SUBJECT: MARKUP OF SSAR SUBSECTION 6.2.4

Enclosed for your review is a draft of AP600 SSAR Subsection 6.2.4. This draft reflects more recent passive autocatalytic recombiner (PAR) performance data. This draft is sent in response to our action from the August 24, 1995 AP600 Senior Management Meeting. Also provided are copies of the EPRI prepared reports "NIS PAR Depletion Rate Equation For Evaluation Of Hydrogen Recombination During An AP600 Design Basis Accident" and "Qualification Of PARs For Combustible Gas Control In ALWR Containments." These reports are provided for your review in response to the discussions with senior management at the August 24, 1995 meeting.

**NIS PAR DEPLETION RATE EQUATION
FOR EVALUATION OF HYDROGEN RECOMBINATION
DURING AN AP600 DESIGN BASIS ACCIDENT**

Figure 6.2-4-1

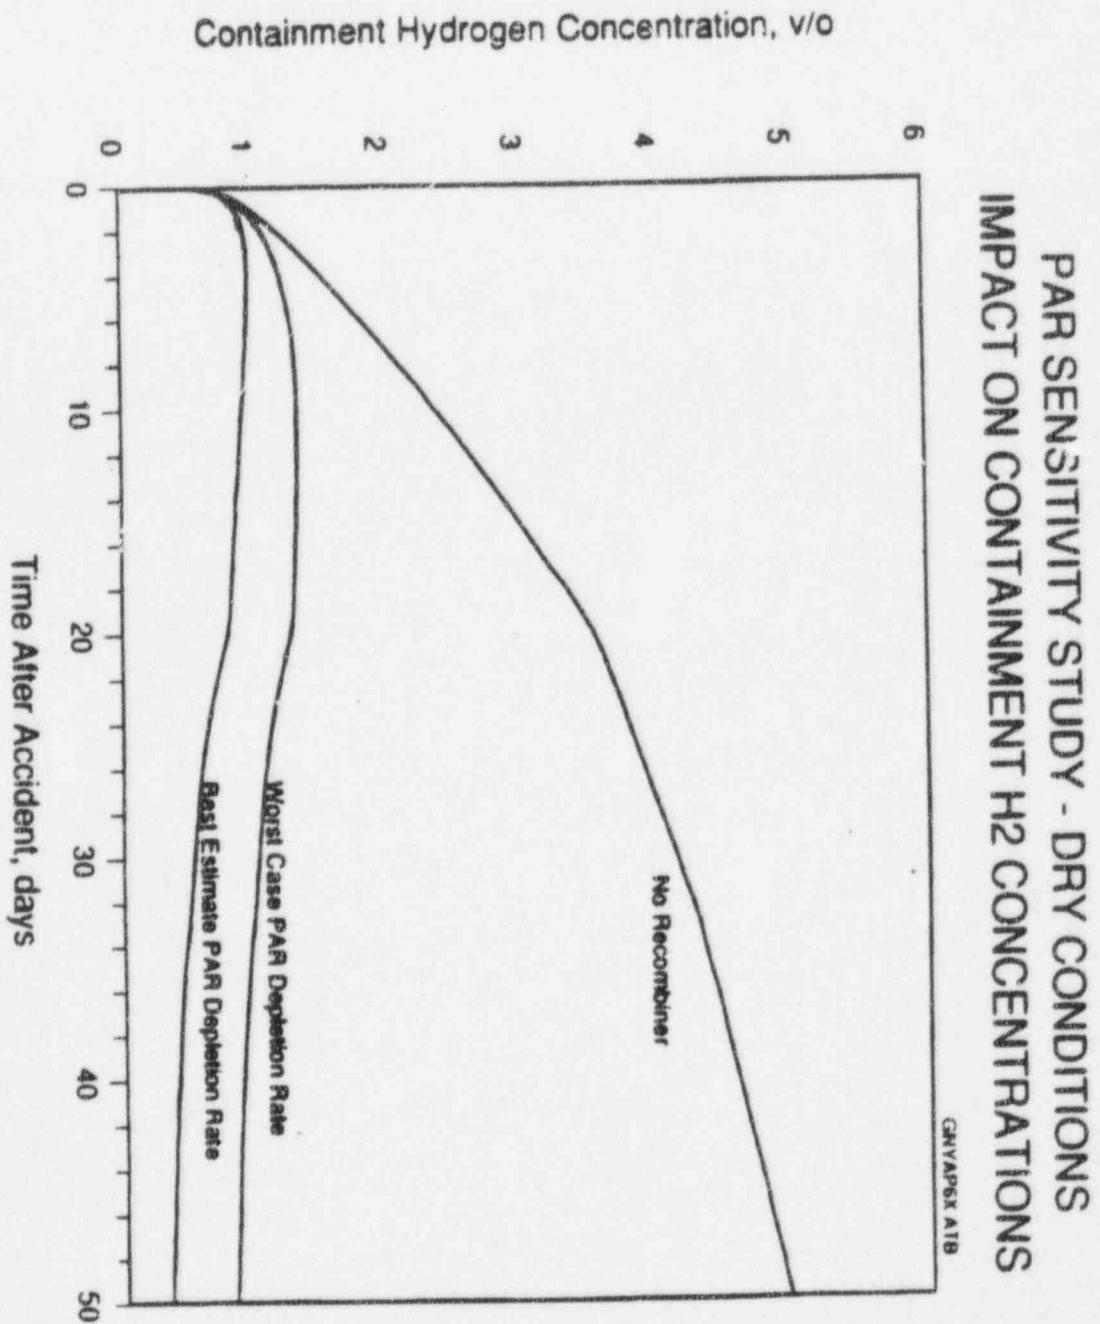
Assuming no hydrogen removal, the concentration of hydrogen in the containment atmosphere increases with time as shown in Figure 6.2.4-31. The curve shows that the flammability limit of four volume percent is not reached until after ~~six~~ 28 days. Hydrogen recombination is initiated ~~begins~~ prior to reaching this limit. ~~The recombiners are brought into service by the time the hydrogen concentration reaches 3.5 volume percent. From Figure 6.2.4-3, this is six days after the accident. Figure 6.2.4-3 also shows the impact of operation of one of the two recombiners on containment hydrogen concentration. The hydrogen concentration is quickly reduced, indicating ample margin in the hydrogen recombiner capacity. The passive autocatalytic recombiners are brought into service by the presence of the reactants. The available PAR test data as discussed in reference 20 supports PAR startup within 7 hours of reaching 1 volume percent hydrogen concentration in containment. Subsequent to PAR startup the conservative lower bound equation for depletion rates provided in reference 20 has~~

been used to predict containment concentrations. Figure 6.2.4-1 also shows the impact of operation of one of the two recombiners on containment hydrogen concentration. The hydrogen concentration never exceeds 1.5 percent which indicates ample margin in the hydrogen recombiner capacity. A further demonstration of the PARs available capacity margin is provided by calculation of containment concentrations with reduced depletion rates. Figure 6.2.4-2 provides the impact of one of two available PARs operating at 20, 10 and 1 percent of the conservative lower bound capacity. The curves provide indication of the abundant hydrogen control margin.
